NATIONAL INTERAGENCY FIRE CENTER

NATIONAL FIRE EQUIPMENT SYSTEM CACHE MEMORANDUM NO. 20-02

Subject: 6000 Lb. Cargo Net (NFES 0458)

Figure 2—Example of a rope end that has been braided past the splice and tucked underneath a different strand. Note that the splice has four (4) tucks.

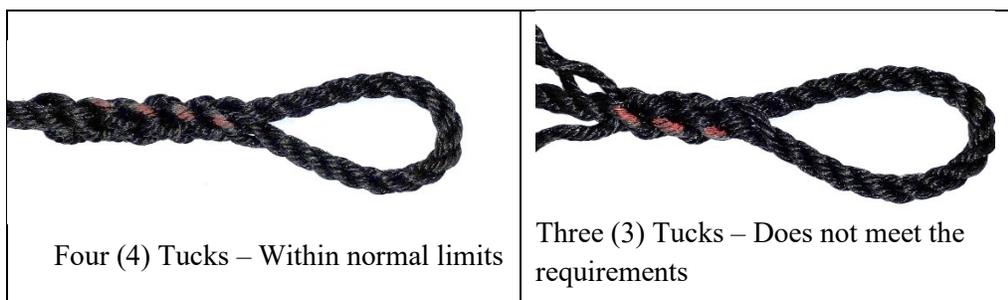
1. Visually inspect all rope terminations and splices for the minimum number of tucks. Note that due to the length of some of the rope ends past the splice, some rope ends were tucked between other rope strands to constrain the extra rope (Figure 2). This condition is acceptable if the splice or termination itself contains the required minimum number of tucks. If any termination or splice has fewer than four tucks, the net should be removed from service.
